**COUNTY OF WESTCHESTER
NEW YORK**

ADDENDUM NO. 3

CONTRACT NO. 20-504

**Rehabilitation of Pool and Bathhouse
Playland Park
Rye, New York**

1
A-505
POOL DECK LEVEL- ENLARGED FLOOR PLAN
SCALE: 1/4" = 1'-0"

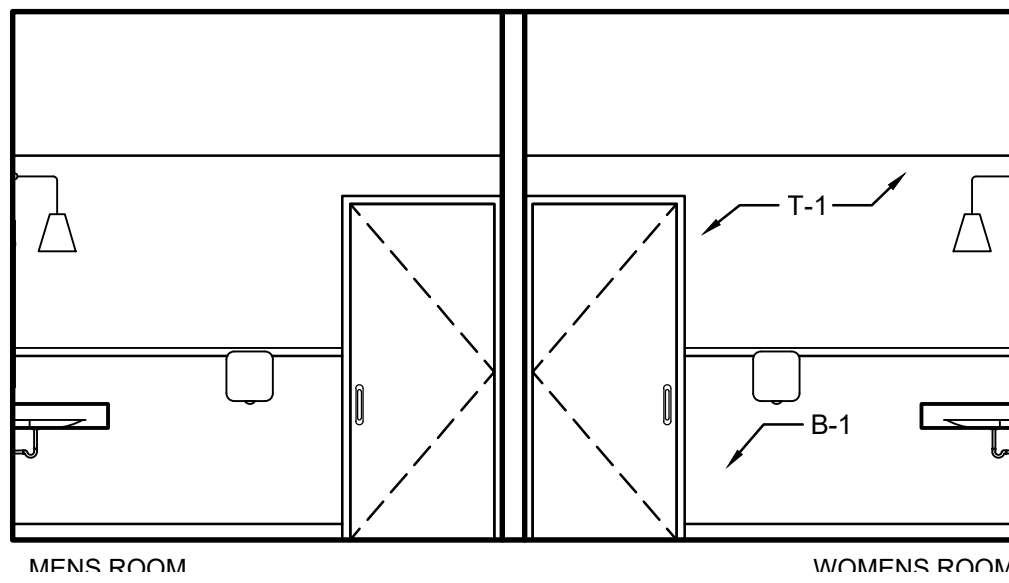
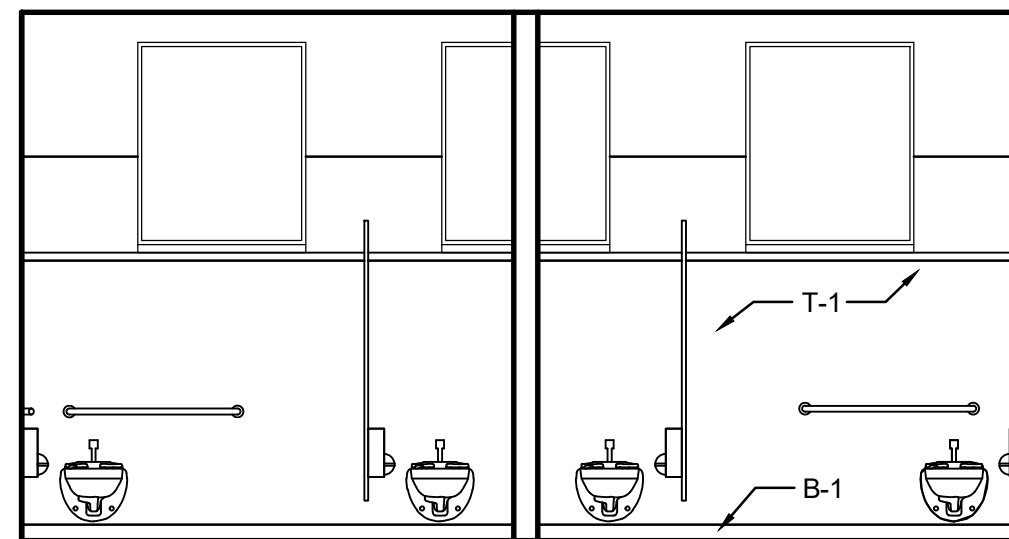
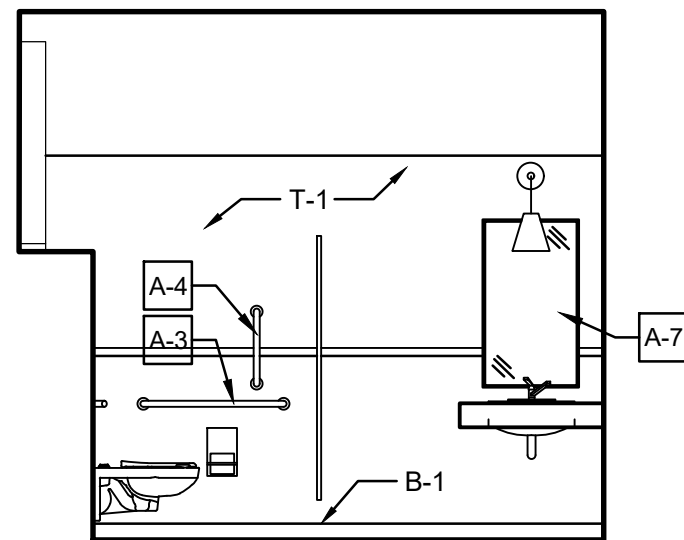
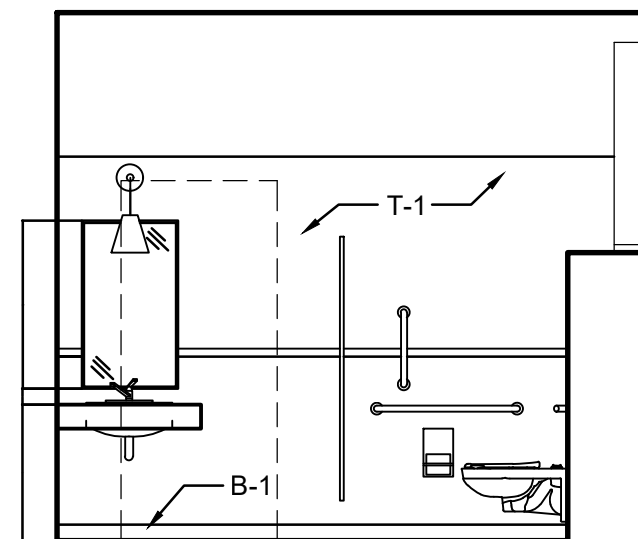
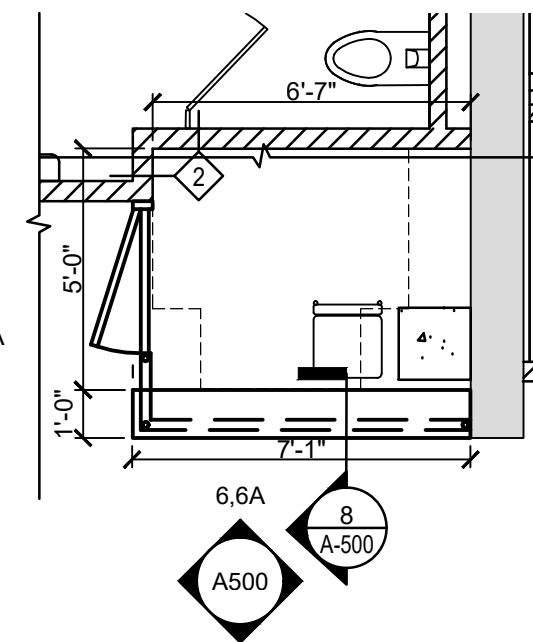
8	<p>RE; DRAWING C-300: NOTE ON DRAWING C-300 READS "BENCH ON CONCRETE PAD (TYP) (BY OTHERS NIC)</p> <p>QUESTION; PLEASE CONFIRM THIS WORK IS NIC.</p>	New benches and concrete pads along the perimeter walkway are not included in this contract.
9	<p>DIMENSIONAL LETTER SIGNAGE spec lists both stainless steel AND aluminum letters. Please clarify which type, font and size (height and thickness) of letters for each of the following: (a schedule of letters would help)</p> <ul style="list-style-type: none"> A. Boardwalk and Restaurant B. Restaurant C. Boardwalk and Cafeteria D. Cafeteria E. Playland Bath 	See signage schedule added to revised drawing A-505.
10	<p>PANEL SIGNAGE spec and the notes below from sheet 4 (G-003) need clarification. A schedule of required signs should be provided by the design team so everyone bids on the same quantities and types.</p>	See signage schedule added to revised drawing A-505.

SHEET NUMBER
SKE-1

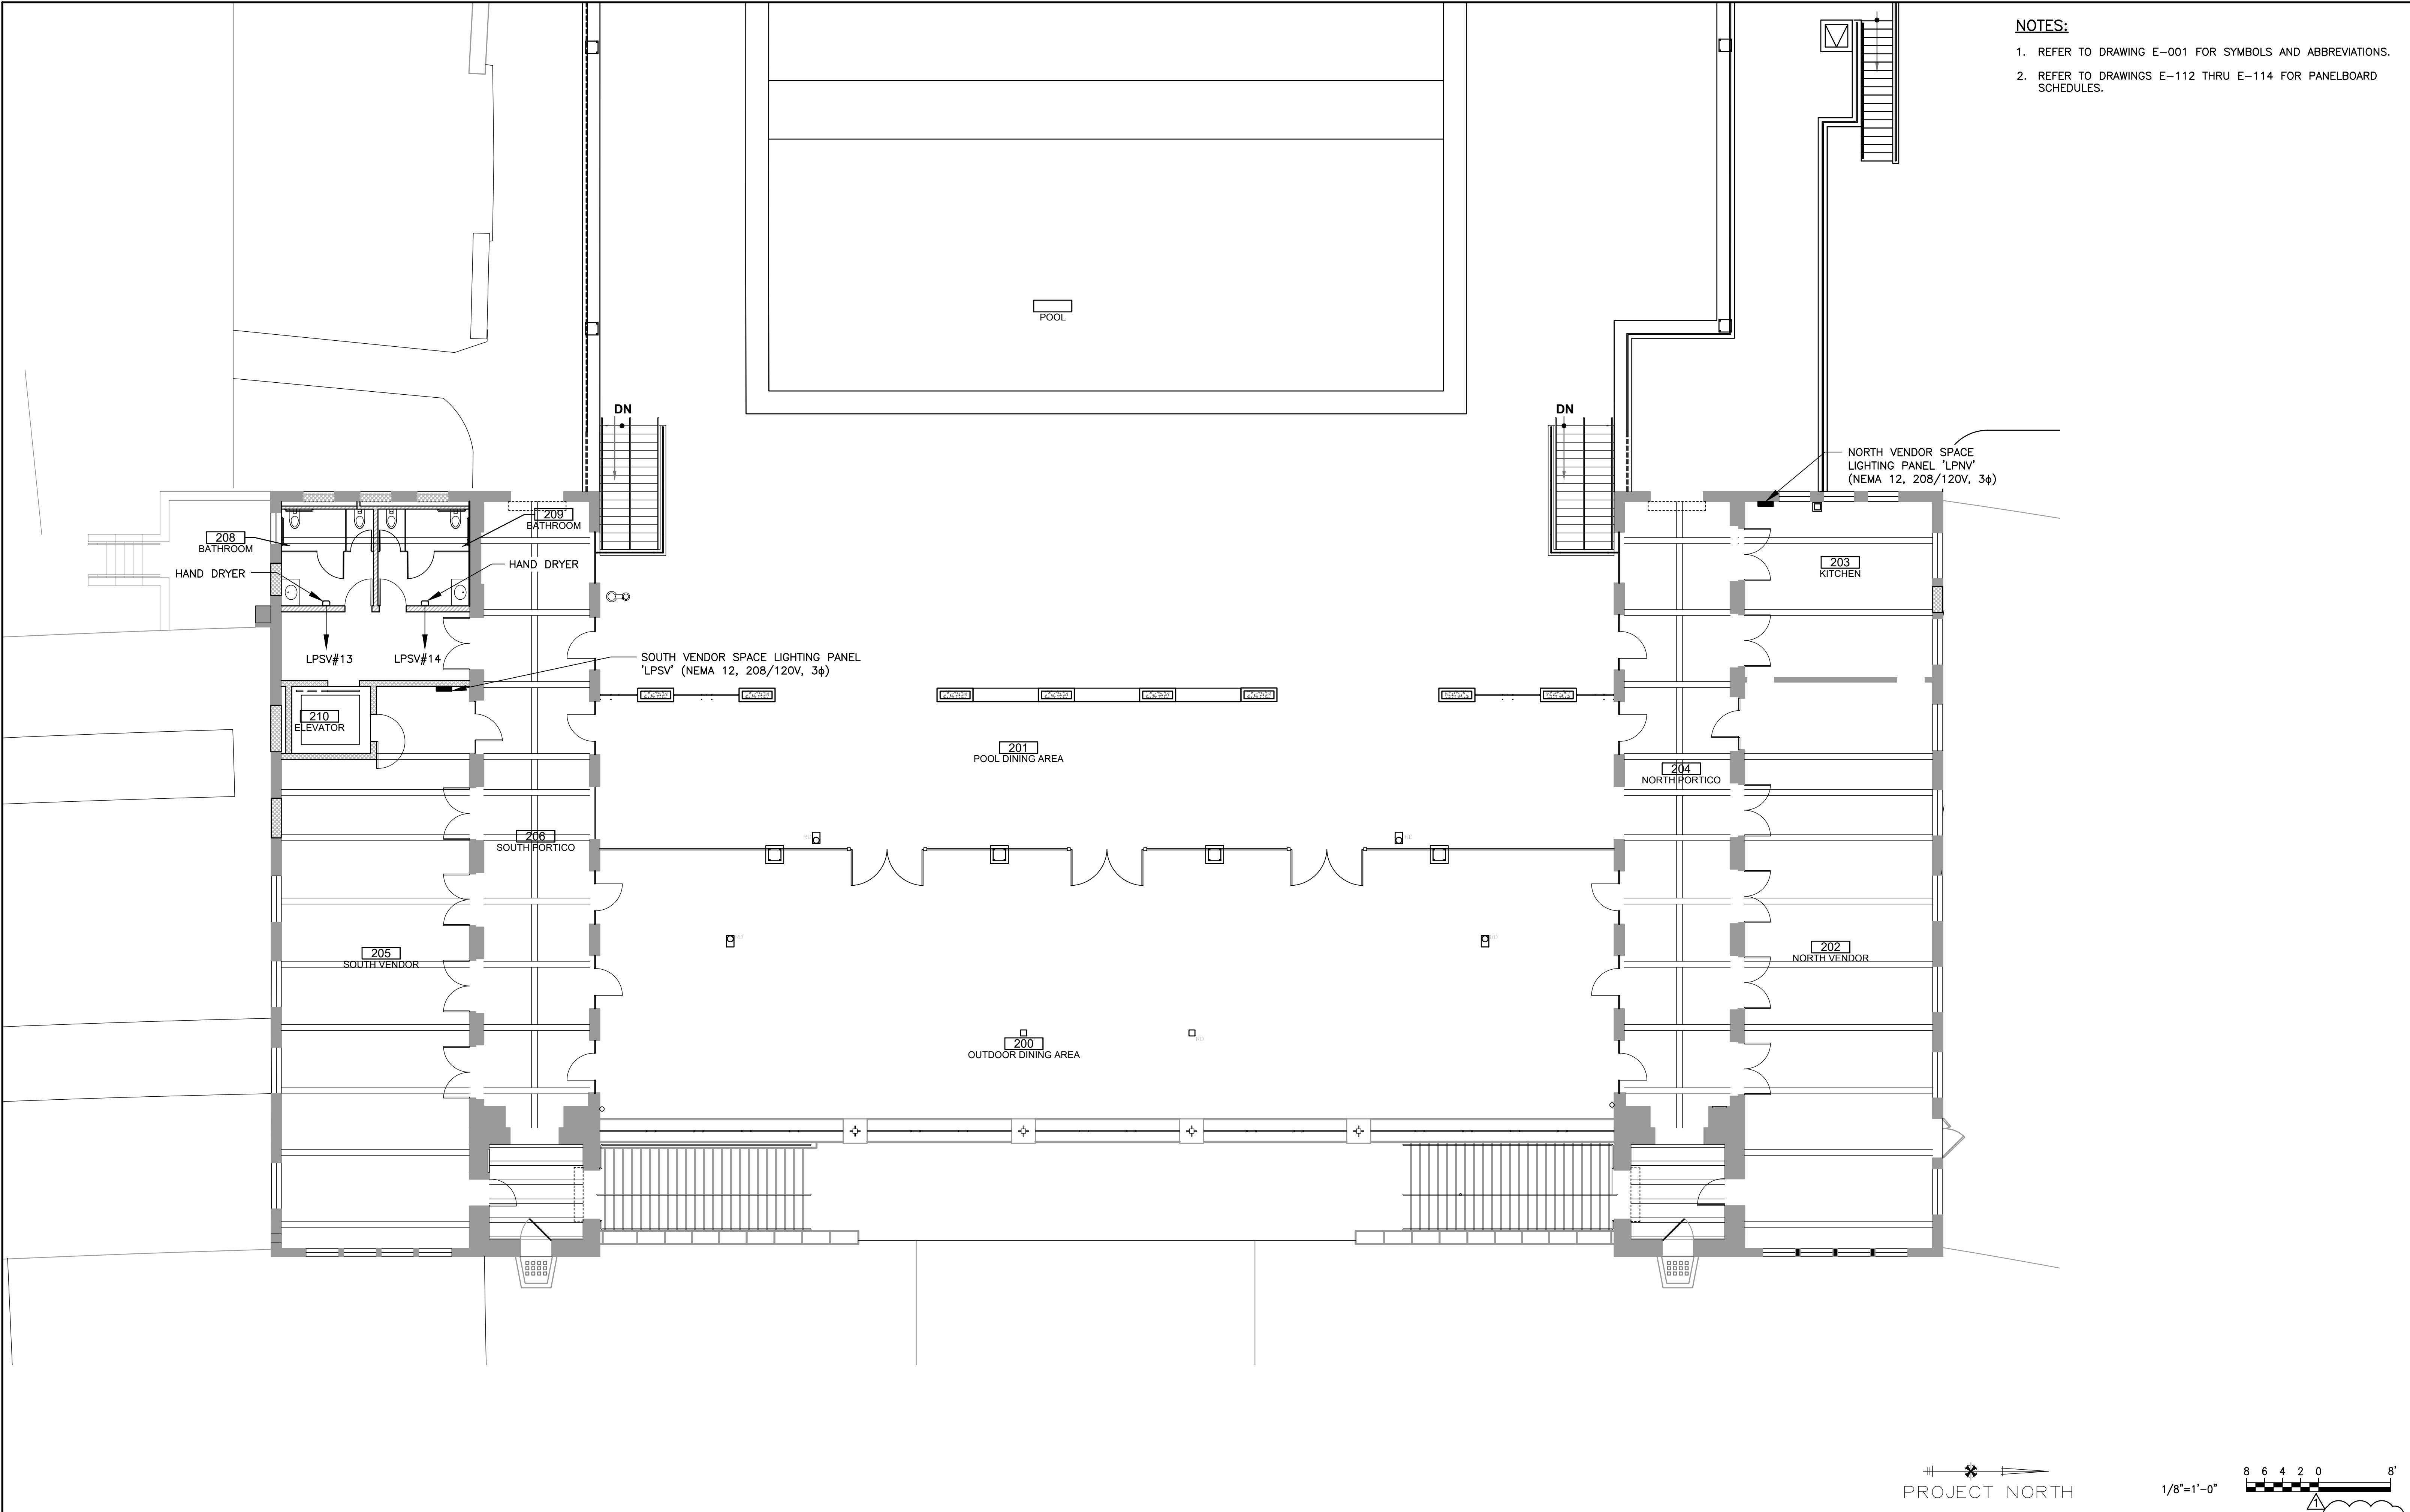
Item 24: Sketch SKE-1, Bathhouse Hand Dryer Sketch is attached hereto to show electrically operated hand dryers.

ENLARGED POOL DECK HAND DRYER SKETCH						
CONTRACT NUMBER 20-504		SHEET NUMBER SKE-2		SHEET NO. — OF 201		SCALE: AS NOTED DATE: NOVEMBER 10, 2020 DPW FILE NO. 1-19-E-514
				REV. NO. 1

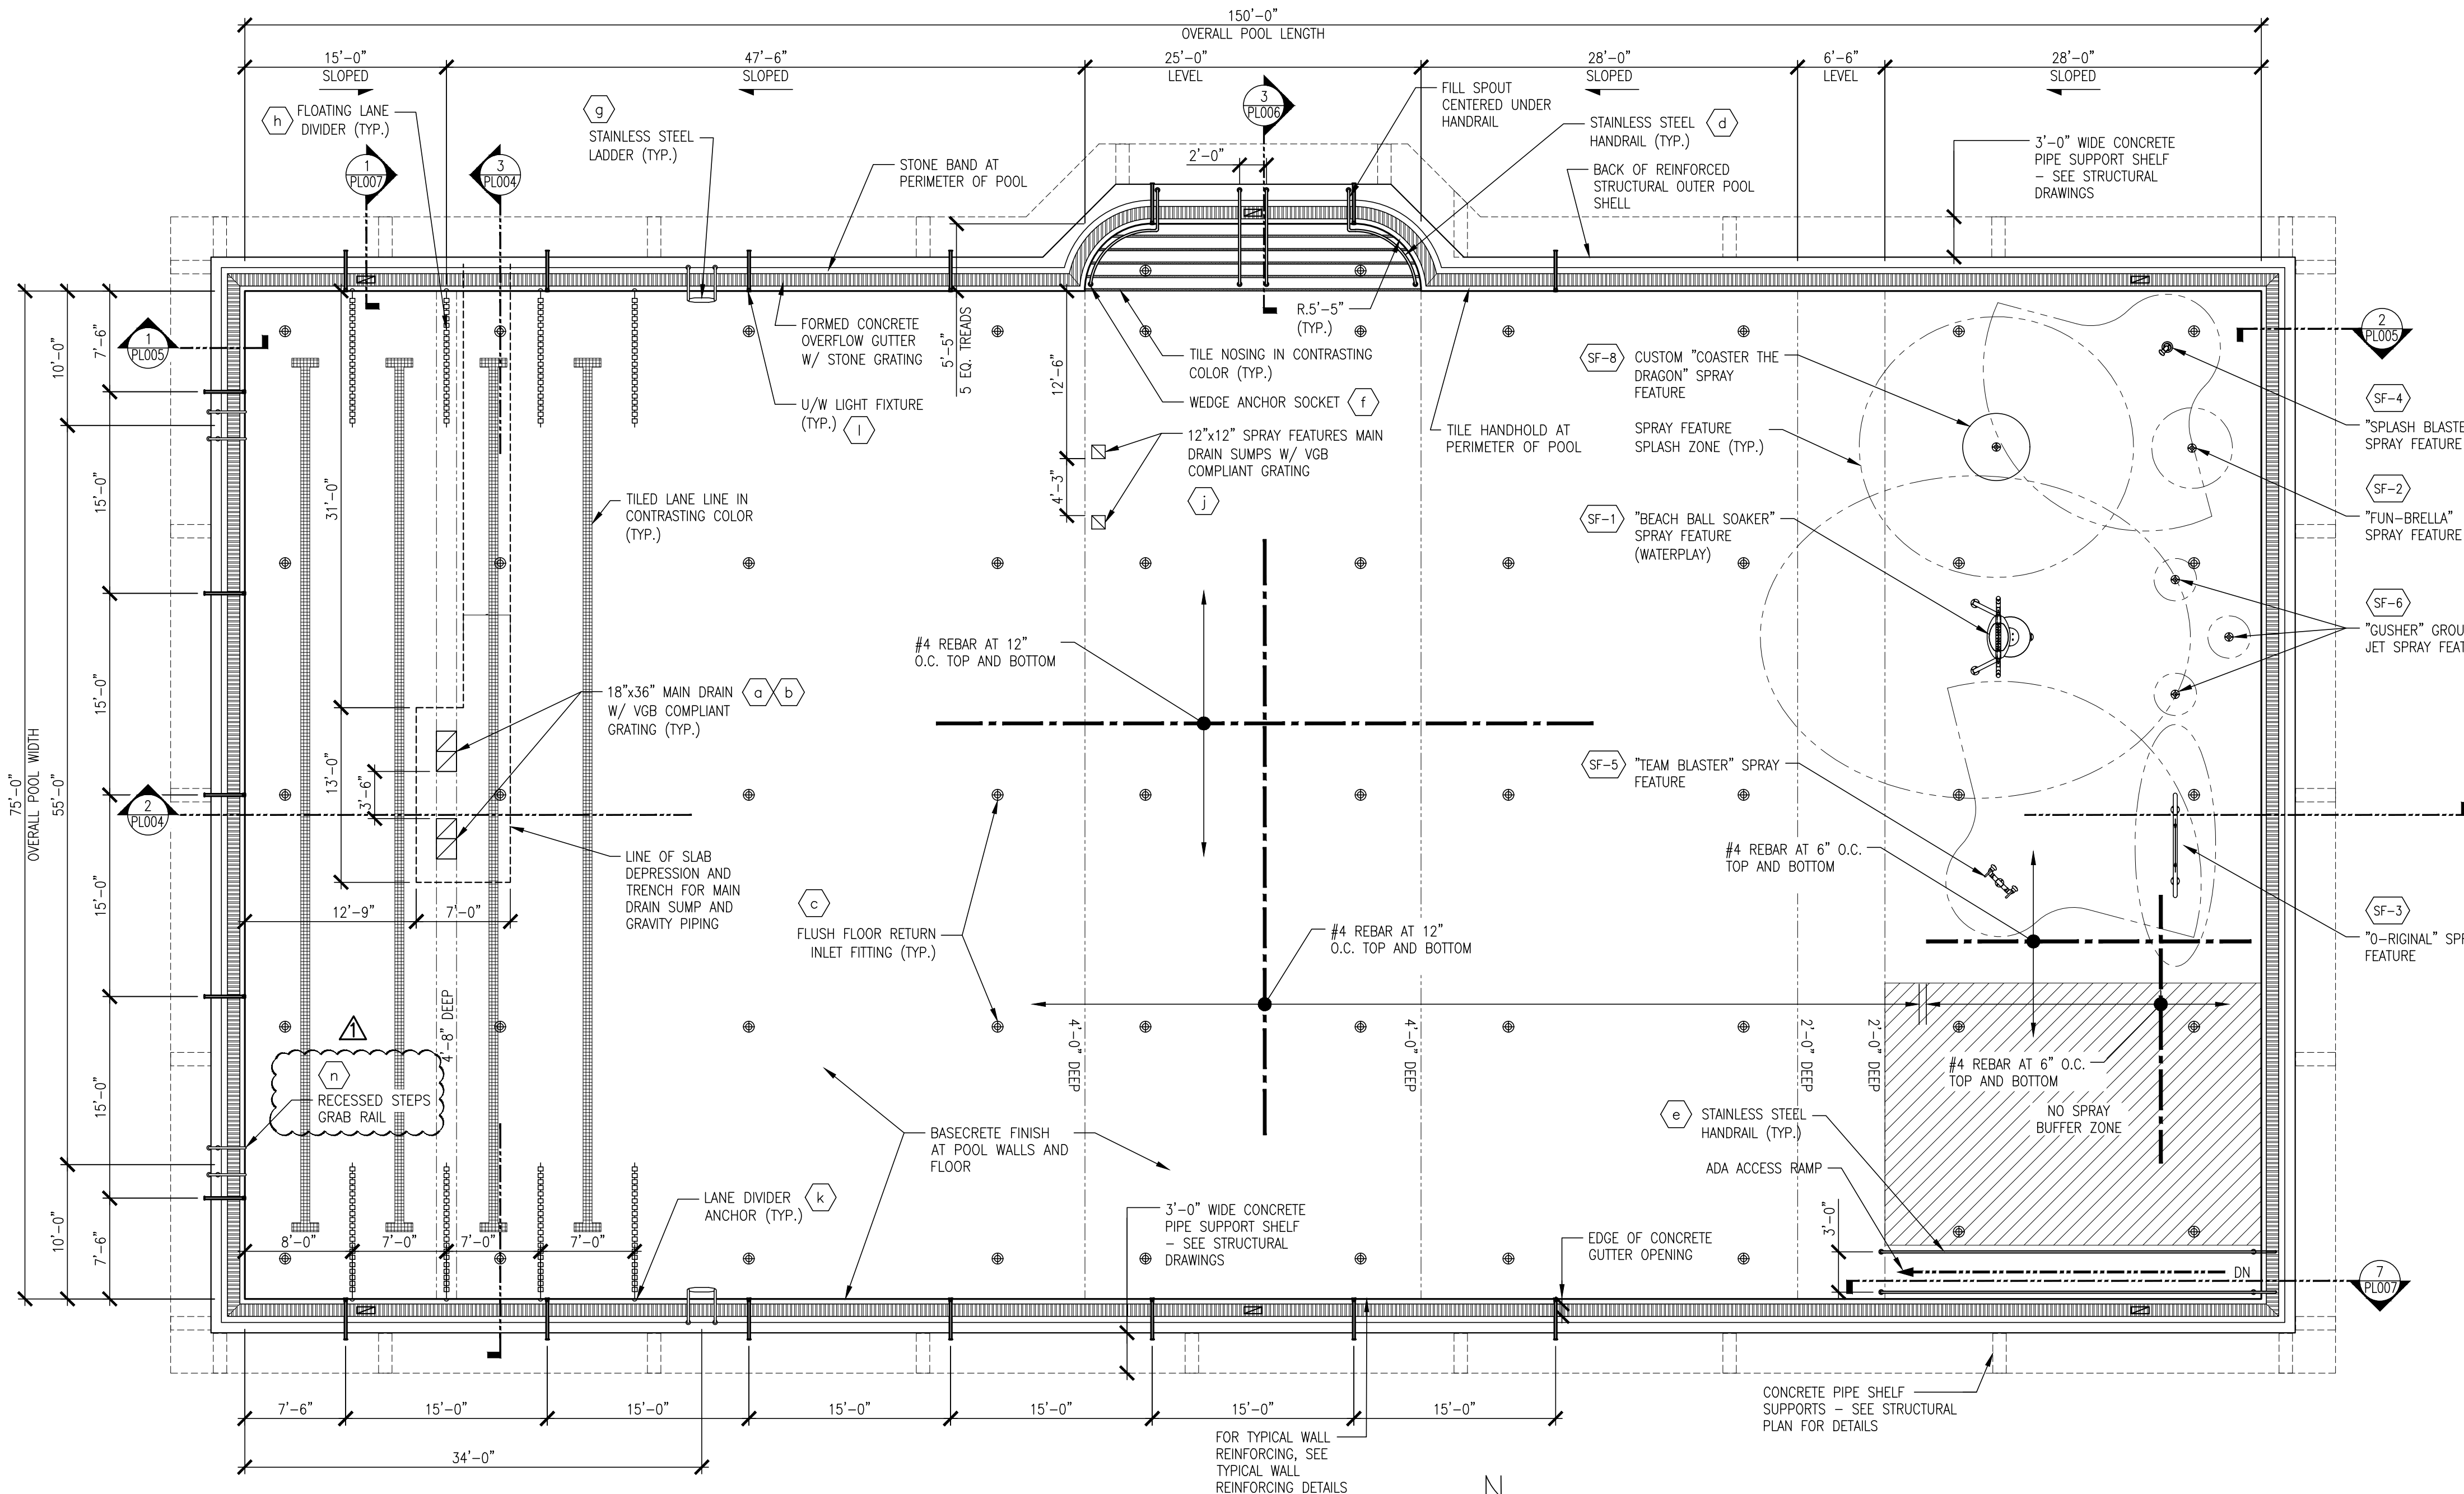
Item 25: Sketch SKE-2, Enlarged Pool Deck Hand Dryer Sketch is attached hereto to show electrically operated hand dryers.
